Interactive comment on “Evaluation of a probabilistic hydrometeorological forecast system” by S. Jaun and B. Ahrens

Received and published: 19 May 2009

We would like to thank the anonymous Referee #2 for his positive and constructive comments. Here we want to address the issues raised by referee #2 and comment on possible modifications to the paper. To ease the overview on comments/requests and the associated responses, we split them into several points.

Fig. 1. Caption Fig. 7: The HEPS median error from observed runoff is compared to the half interquartile HEPS range for daily runoff [mm] (72–96h hindcasts) for catchments C1 to C23 in 2005. The ...

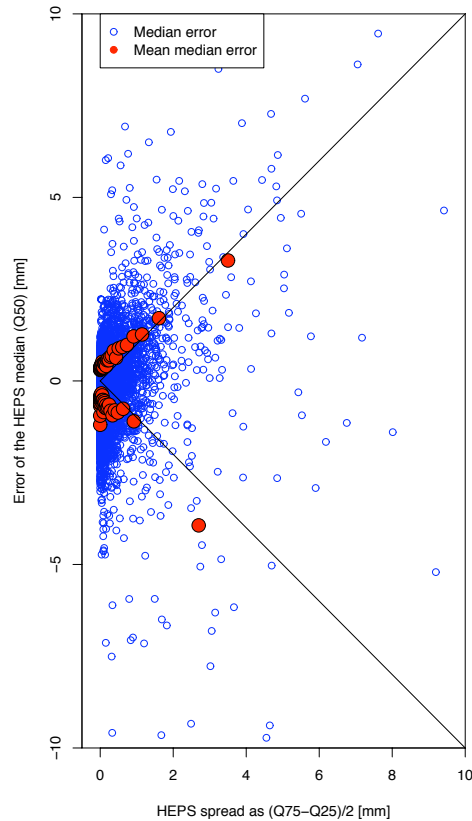
(3) The assumption that the second and third quartiles are symmetrical (Lalaurette et al, 2005) could be commented in regard of Fig. 6.

(4) The authors are appropriately replying to one possible drawback cited by Lalaurette et al (2005) by testing also their artificial ensemble (HART) which is described p. 1853. The results are mentioned p. 1859 but unfortunately not shown. (...) Wouldn't the spread-skill relationship of HART be more informative than Fig. 7 (HEPS compared with observed runoff)?

(5) In Fig. 7 and 8, the results are presented together for all the catchments. This includes catchments of the same river at different gauge locations (Table 1). Doesn't such a mixture contribute to the good statistical relationship obtained? A more detailed analysis could take a better profit of this large dataset. (...) The comment about merging the results of all catchments applies also to the RPSS.

(6) Given the large dispersion of the blue circles in such graphs, wouldn't error bars help in assessing the relationship?

Thank you for bringing this aspect up. The assumption that the error-quantiles are symmetrical is certainly not met in this application. We would therefore like to replace Fig. 7 and Fig. 8 with the extended version attached to this reply in order to avoid oversimplified results. The discussion of the two figures will be extended, as more details/aspects need to be covered. We need to add that large negative errors are not met by a sufficiently wide ensemble spread for longer lead times. This underestimation of spread disappears with shorter lead times and results from a single event (August 2005). Excluding the period of this event also removes the underestimation of spread.

While we do not show a figure for the spread-skill relation, a chained plot for HART is shown in Fig. 5. We think that the important messages regarding HART are a) constant spread as HART cannot identify uncertainties associated with a specific weather situation and fully relies on the given runoff value and b) HREF performs better in terms of the RPSS. Therefore we think that additional figures for HART would overemphasize this part. We would prefer not to replace the figure showing the evaluation against observed runoff, as the comparison between the results with HREF and OBS allows the identification of the hydrological model error. Nevertheless we agree that HART should be discussed in section 3.3 and not only mentioned in section 3.4. We will therefore shift and slightly extend this part.

We merged the results of all catchments mainly to evaluate the respective forecast systems in a general way, without restrictions to climatological/topographical conditions on the catchment scale (e.g. positioned in the lee of a specific mountain range) and specific catchments/catchment sizes. Also we tried to achieve a condensed and clear presentation of the results, which is only possible at the cost of details. Your concern regarding a possible benefit of scores through the consideration of downstream gauges is generally valid (the bigger the catchment grows, the better the scores should get through compensation/averaging of errors). While we totally agree to this point of

An interesting suggestion, but, in our opinion, there are several reasons not to replace the circles by error bars: a) Given the large number of categories, error bars would be messy and would not improve the figure in terms of clarity b) People are well accustomed to point-clouds in dot-plots c) While the blue circles are not interpreted individually, the large dispersion shows the high daily variability, an aspect we would like to show.

Caption Fig. 7 (to long to be accepted by the upload form): The HEPS median error from observed runoff is compared to the half interquartile HEPS range for daily runoff [mm] (72–96h hindcasts) for catchments C1 to C23 in 2005. The empty blue circles represent the daily values, while the filled red circles show the means of the spread categories, averaged over 100 daily values. Positive and negative errors are considered separately.
